NOTICE OF DECISION

DECISION OF THE PLANNING ADMINISTRATOR

CLASS 3 SITE PLAN REVIEW / CLASS 2 ADJUSTMENT / CLASS 2 DRIVEWAY APPROACH PERMIT / CLASS 1 DESIGN REVIEW CASE NO.: SPR-ADJ-DAP-DR22-17

SUMMARY: A proposal to construct a new 200-unit apartment complex.

SITE PLAN

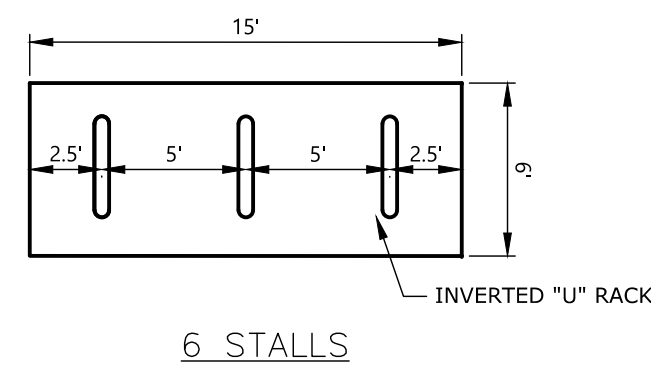
Finding: A proposed internal street, "P Avenue" creates an abutting street setback to the north of proposed buildings 18 and 19. However, the setbacks to "P Avenue" will only apply upon right-of-way dedication and/or land division. The two proposed buildings are both approximately 35 feet in height, requiring a minimum setback of 20 feet. The site plan shows a setback of between 20 to 23 feet for Building 18, and 20 to 25 feet for Building 19 to the proposed right-of-way line of "P Avenue." The vehicle use area is set back 20 feet from the proposed right-of-way of "P Avenue."

The two proposed buildings abutting proposed "P Avenue" to the south are buildings 3 and 16; both are 35 feet in height, requiring a minimum setback of 20 feet. The site plan

Finding: One internal street, proposed as “O Street,” creates abutting street setbacks to the east in this development proposal. The one proposed building abutting “O Street” to the east is Building 17 and is approximately 35 feet in height, requiring a minimum setback of 20 feet. The site plan shows a setback of 21 feet, exceeding the standard.

As displayed on the site plan, the setback for Building 17 is between 17 and 22 feet, and the vehicle use area is north of the building, exceeding the 10-foot minimum setback. It is unclear if Type C landscaping is proposed. As conditioned within this decision, the proposal will meet this standard.

Finding: The proposed site plan shows pad areas of 45 feet wide by 25 feet deep for Solid Waste Service Area One and a pad area of 15 feet wide and 11 feet deep for Solid Waste Service Area Two, allowing for adequate clearance to the front, rear, and sides of the receptacles. The amount of detail provided in the application submittal materials does not indicate the vertical clearance, minimum separation or whether the compactor placement standards are met. As such, the following condition of approval shall apply:

Finding: The proposed site plan shows openings on the front of the enclosures of 12 and 15 feet. The proposal meets the standard.

Finding: The proposed site plan shows areas a minimum of 45 feet in length and 15 feet in width, perpendicular to the enclosures and extending into vehicle maneuvering areas. The proposal meets the standard.

Finding: The proposed site plan shows vehicle operation areas perpendicular to the enclosure openings but does not indicate the size of the receptacles. As conditioned, the proposal will meet the standard.

Finding: The proposal includes 200 dwelling units, with 38 one-bedroom units and 162 units with two or more bedrooms. The development requires a minimum of 281 parking spaces ($(1 \times 38 = 38) + (1.5 \times 162 = 243) = 281$). The site plan proposes 348 off-street parking spaces, which meets the minimum standard.

Based on a minimum off-street parking requirement of 243 spaces, a maximum of 211 spaces may be compact spaces. As shown on the applicant's site plan, 115 are proposed as compact spaces, meeting the compact parking space allotment standard set forth in SRC 806.015(b).

Finding: The proposed development includes 200 dwelling units, requiring a minimum of 20 spaces ($200 \times 0.1 = 20$). The proposed site plan shows 20 bicycle parking spaces, placed in five locations throughout the development site. The proposal meets the standard.

Condition 2: Unless a greater setback is required, interior side and rear property lines shall have a minimum setback of 10 feet with Type C landscaping and screening; landscaping as required under Salem Revised Code 702.020(b) may count toward this condition.

Condition 4: At the time of building permit application, solid waste service areas shall comply with the standards of Salem Revised Code 800.055.

SOUTH ELEVATION (TYPE C UNITS)
SCALE: 1/8" = 1'-0"
BLD. 17

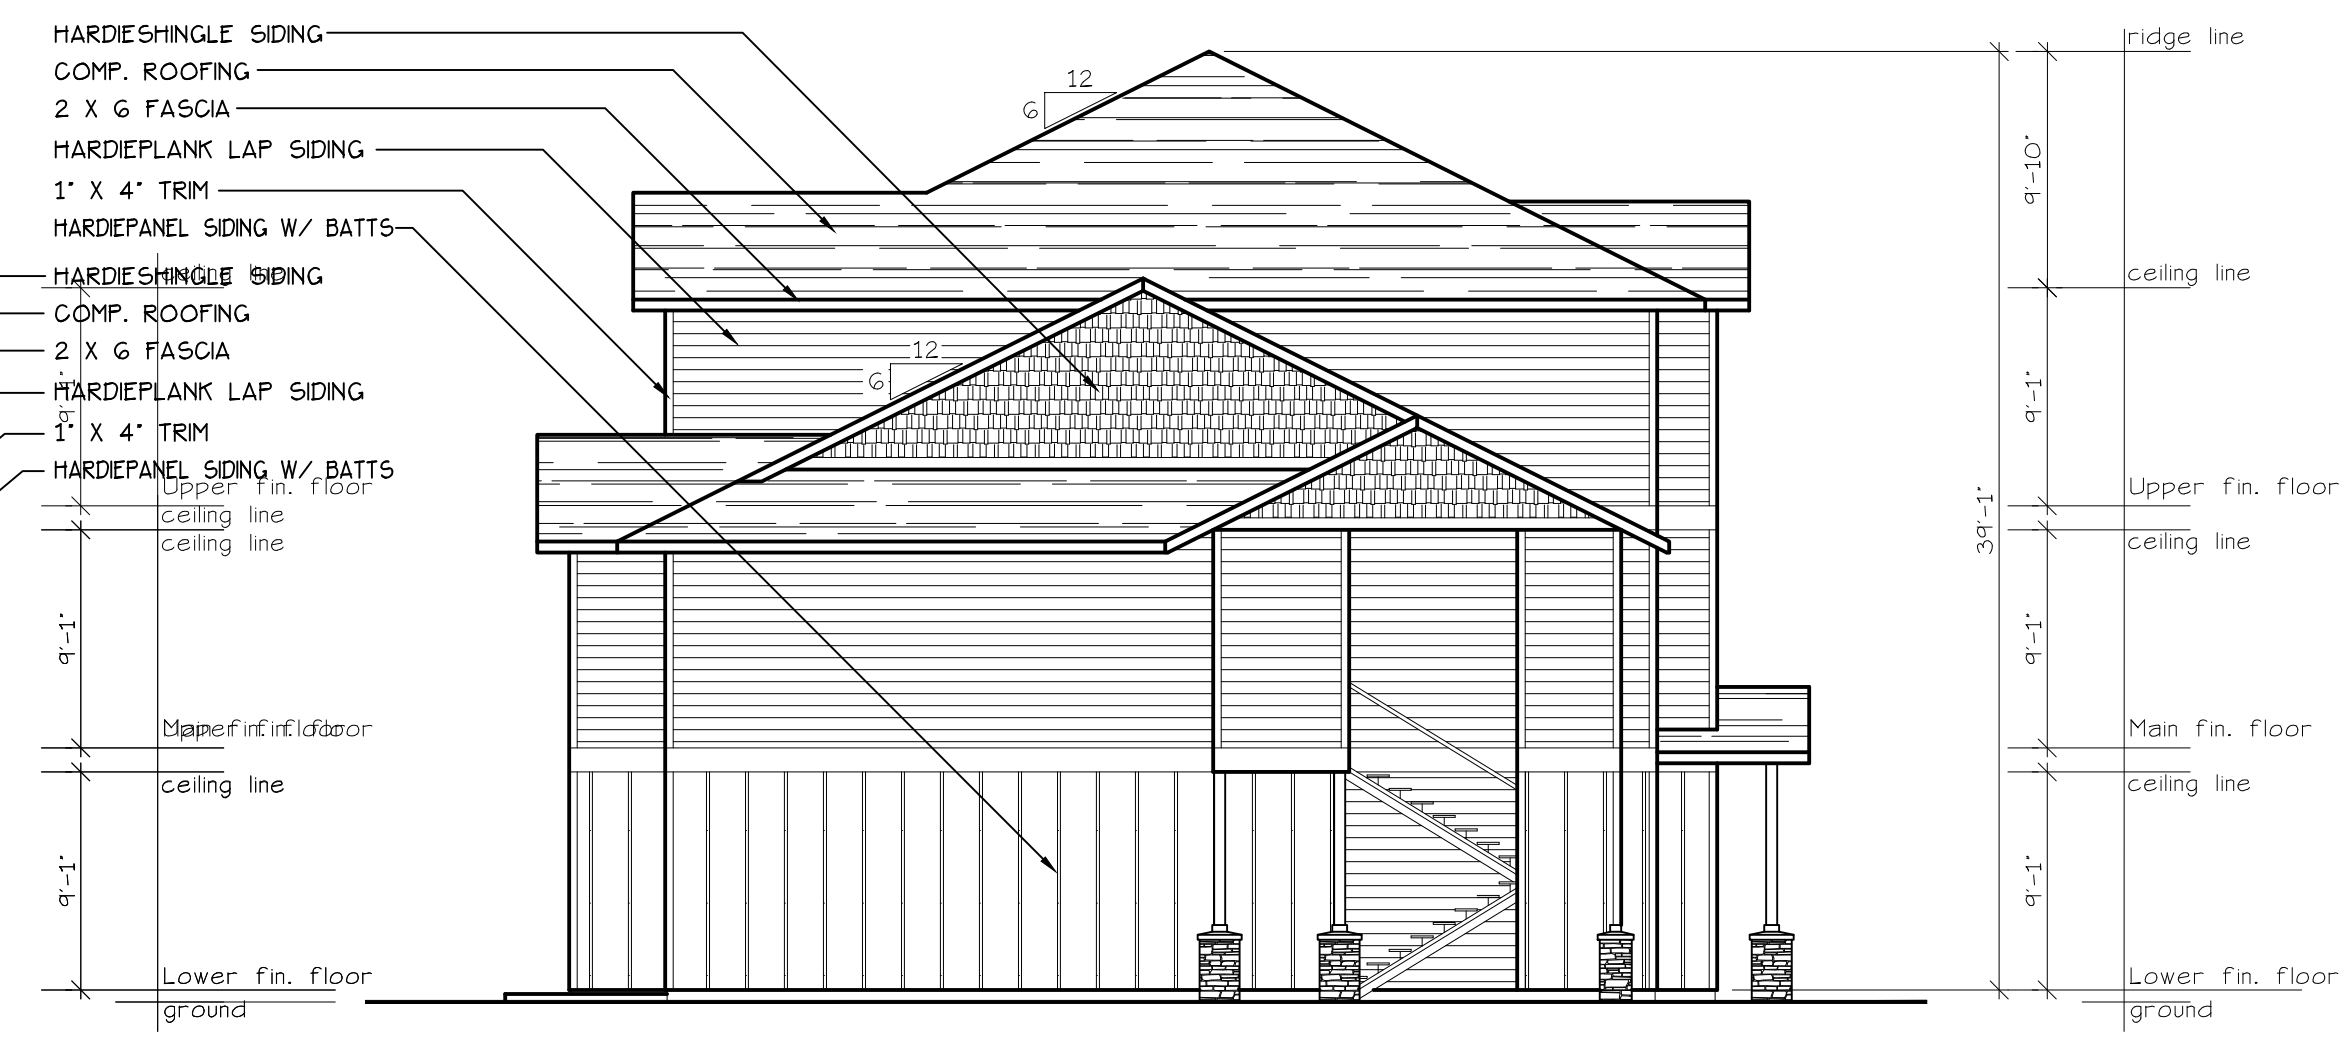
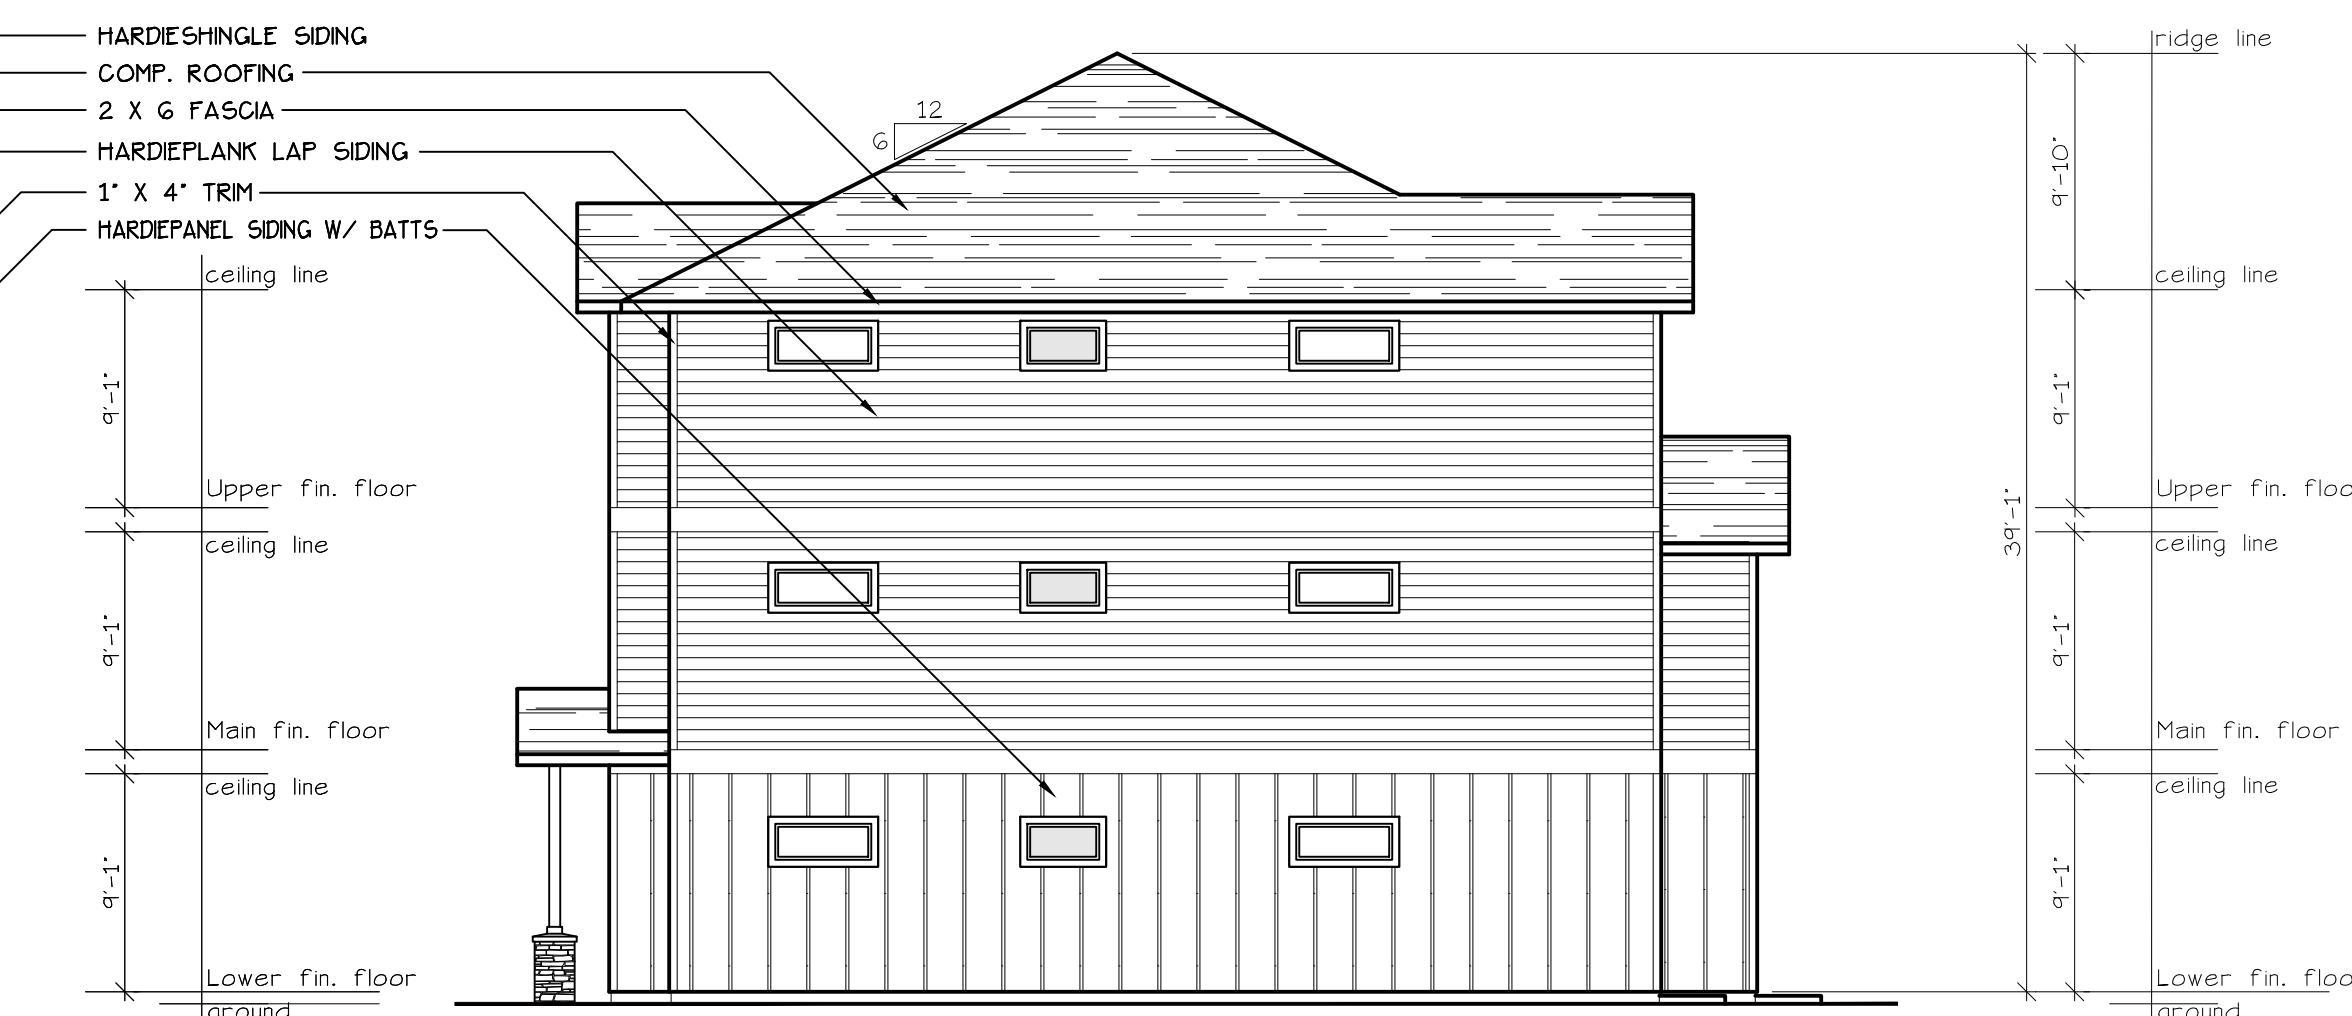
The applicant has requested an Adjustment to SRC 702.020(e)(4) for three of the proposed buildings: 17, 18, and 19. In summary, the applicant's written statement indicates the underlying purpose of the standard is to provide a pedestrian friendly development with buildings located close to the sidewalks. The applicant notes challenges related to lot shape in terms of locating these three buildings adjacent to the proposed internal streets.

Staff notes the triangular shape and large buildable width (approximately 130 feet) of the property containing proposed Building 17 makes this standard quite difficult or impossible to meet while still meeting the other provisions of the UDC, such as minimum off-street parking and setback standards. However, the street-abutting property line adjacent to proposed buildings 18 and 19 is relatively straight and the property is almost rectangular in shape, and Staff notes the applicant did not provide sufficient justification for this Adjustment for buildings 18 and 19.
